# North Torquay Constructed Wetland Assessment

Version 2.3

The purpose of this investigation was to review existing stormwater treatment wetlands located in the north Torquay catchment.

This involved reviewing wetland designs, assessing wetland condition and performance and recommending measures to improve wetland function to better protect the downstream Karaaf wetland ecosystem.

Figure 4 The Dunes Wetland.

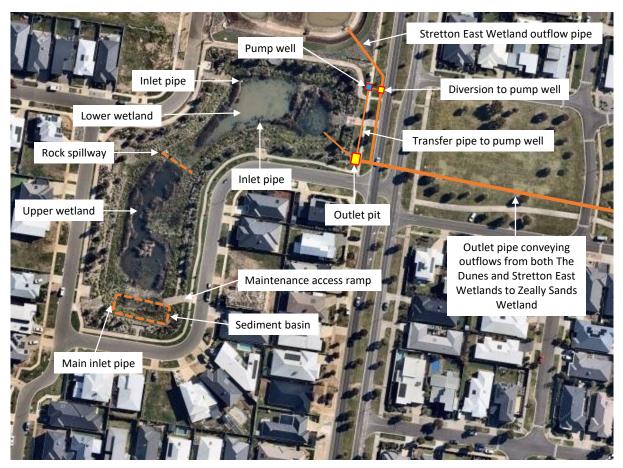
- 1. The sediment pond is too shallow consider deepening to increase sediment capture storage and reworking connection to the wetland (e.g. remove existing pit/pipe and replace with simpler weir)
- 2. Inlet pipe blockages on small inlets remove vegetation and sediment build up around the inlet and install cement treated rubble to prevent future growth
- 3. There are more open water pools than best practice plant more robust submerged plants to improve treatment
- 4. Remove some stands of Typha.

| Component                | Issue  | Action   |
|--------------------------|--|--|
| Sedimentation            | There is notable sediment accumulation<br>adjacent to both small inlets to the wetland.<br>It is likely that there has also been<br>significant sedimentation throughout the<br>wetland, as indicated by the extensive<br>growth of water plants in areas which<br>designed as open water areas.   | Remove the accumulated sediment adjacent to the inlet areas.   |
| Blocked inlet pipe       | The NW inlet pipe to the lower wetland was<br>blocked with vegetation and sediment.<br>Consider clearing the inlet pipe opening but<br>where possible retaining the sediment as it<br>is enabling emergent water plants cover to<br>extend into the open water zone.<br>It was noted that Council have recently<br>installed a screen below each of the lower<br>inlet pipes to trap sediment. The growth of<br>emergent water plants into this zone would<br>raise the question as to whether there is<br>merit in removing the sediment given the<br>scale of the adjacent sub catchments and/or<br>the benefit that the vegetation cover will<br>provide to wetland function. | Unblock the pipe entries, remove sediment<br>and plants and install cement treated rubble<br>to prevent future plant growth at the pipe<br>outlet.   |
| Blocked balance pipe/pit | The water level on the upstream side of the<br>rock spillway appears to be sitting at the top<br>of extended detention (crest of the<br>spillway), indicating that the balance pipe<br>system may be blocked. It is likely that this<br>has been the case for some period of time,<br>given the growth form of the emergent<br>water plants (particularly groundcovers)<br>present within the upper wetland zone.<br>We did not inspect the wetland outlet pit,<br>however a similar observation was made<br>during the recent wetland audit (Water<br>Insights, 2022).  | The balance pipe system needs to be<br>unblocked to re-instate NWL within the<br>upper wetland. This will lower the water<br>level by approximately 0.3m, and provide<br>conditions for water plants to grow<br>throughout the wetland zone. Note: it is<br>important that any water plants and<br>accumulated sediments adjacent to the<br>balance pipe inlets/outlets are also removed<br>during this task to prevent future blockage.   |
| Bathymetry               | The design of the wetland comprises of a series of interconnected deep pools ranging between 0.7-1.2 m depth. This design provided for shallow zones around the margins of the pools for water plant growth, however the majority of the wetland comprised of submerged/open water areas (nearly 60%). Wetlands with interconnected open water zones are generally   | While the wetland design has too many<br>deep pools and not enough shallow<br>vegetated areas compared to best practice it<br>is not recommended to make wholesale<br>changes. Rather it is recommended to plant<br>robust submerged water plants to improve<br>treatment (e.g. Valiseneria australis).  |

Figure 7 Layout of the Zeally Sands wetland complex.

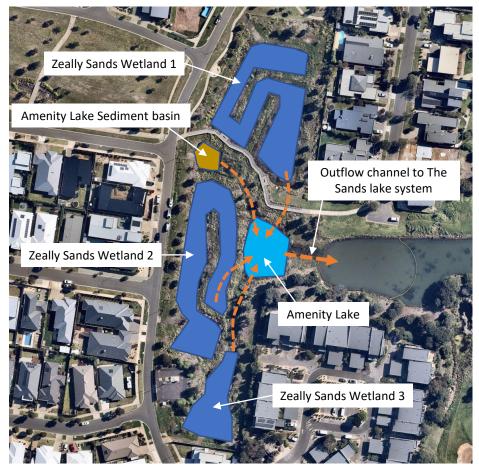
- 1. Wetland designs seem overly complex leading to a lot of area given up to batters
- 2. Generally in healthy condition with robust vegetation cover
- 3. All wetlands are designed with very deep (600mm) EDD that is likely to affect plant health (it is likely it is not currently operating as designed this should be investigated and reconfigured to achieve 350mm if possible
- 4. Wetland 3 is very small for its catchment but still in good condition
- 5. Inlets ponds all need cleaning (particularly the amenity pond sediment basin)
- 6. There appears to be backwater from the lakes in The Sands which may affect wetland levels and outflows- needs further investigation.

| Component             | Issue  | Action   |
|-----------------------|--|--|
| Sediment accumulation | The extensive growth of emergent water<br>plants around the margins of the lake<br>indicative that the lake may be filling with<br>sediment.   | It is recommended that sediment levels<br>within the lake are surveyed to establish the<br>level of sediment accumulation. If less than<br>800mm then the lake should be cleaned<br>The growth of water plants within the lake<br>is highly beneficial to water treatment,<br>however, continual accumulation will<br>reduce its capacity to further prevent<br>sediments reaching The Sands.<br>Removal of accumulated sediments will<br>ensure that the lake continues to effectively<br>trap the sediments. |
| Lake water level      | The lake water level was observed to exceed<br>the crest of the overflow weir by 0.1-0.15m.<br>A similar observation was made during the<br>wetland audit (Water Insites, 2022) which<br>found the water level exceeded NWL by<br>0.17m.<br>It is understood that the lake water levels<br>throughout The Sands lake system were<br>recently increased to enable additional<br>storage capacity within the system. It is<br>possible that modifications to The Sands<br>Lake 1 overflow weir has increased the NWL<br>of the amenity lake. | Undertake further investigation of the<br>amenity lake water level. Confirm that the<br>overflow weir below The Sands Lake 1 is free<br>of obstructions.<br>A permanent increase in the amenity lake<br>NWL may impact the operating water levels<br>in all three wetlands and the amenity lake<br>sediment pond.  |

Figure 9 Zeally wetlands 2 & 3

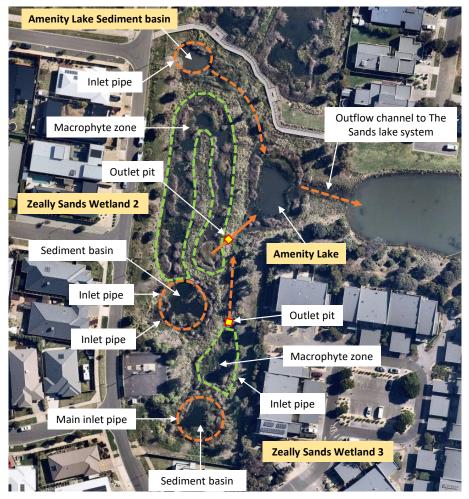
| Component                | Issue  | Action   |
|--------------------------|--|--|
| Extended detention depth | The design EDD for the wetlands varies<br>between 0.5- 0.6m. This is too deep to<br>sustain water plants within a constructed<br>treatment wetland.  | It is recommended that a maximum EDD of<br>0.35m be adopted for the wetlands. This will<br>require that the outlet riser pipes within the<br>outlet pits are modified to accommodate<br>both reduced EDD and 72 hr drawdown.   |
| Outlet pit               | The wetland water levels appear to be very<br>stable, with little evidence of water level<br>variation on the stems of the emergent<br>water plants.<br>The outlet pits were unable to be opened<br>during the inspection due to heavy concrete<br>lids, however water could be heard passing<br>through the pits.<br>It is suspected that the outlet riser pipes<br>within the pits may be partially blocked, | The outlet control pits should be inspected<br>and the wetland EDD verified.<br>Blockages present within the pit should be<br>removed and the design NWL for the<br>wetland re-engaged.<br>It is recommended to consider replacing the<br>concrete lids with grated lids which are<br>more accessible for maintenance staff.<br>Note: The wetland design plans indicate<br>that the outlet pits should have a grated pit<br>lid. |

|            | resulting in wetland water levels being maintained at or near the TED.   |  |
|------------|--|--|
| Bathymetry | The bathymetric design of the macrophyte<br>zones comprises of a series of<br>interconnected deep pools ranging between<br>o.4-1.0 m depth. This design provides for<br>shallow zones around the margins of the<br>pools suitable for water plant growth,<br>however the majority of the macrophyte<br>zones comprise of open water areas.<br>Whilst the macrophyte zones appear to be<br>well vegetated when viewed from the<br>margins, a review of aerial imagery indicates<br>that both wetlands have significant open<br>water areas. These are generally consistent<br>with the wetland design plans which<br>indicate a series of deep pools.<br>Wetlands with interconnected open water<br>zones tend to short circuit as water flow<br>directly to outlets.<br>Some of the open water areas within the<br>wetlands may have filled with sediment,<br>enabling the growth of emergent water<br>plants across parts of the macrophyte zones<br>which is beneficial. | Ideally, some of the open water areas<br>should be infilled to enable lateral bands of<br>emergent water plants to be established<br>within the macrophyte zones. This would<br>increase the interaction with water plants<br>to improve treatment.<br>However, filling these areas would disturb<br>the existing vegetation. It is recommended<br>to retain the existing bathymetry and just<br>modify the outlets to increase the volume of<br>stormwater treated. |
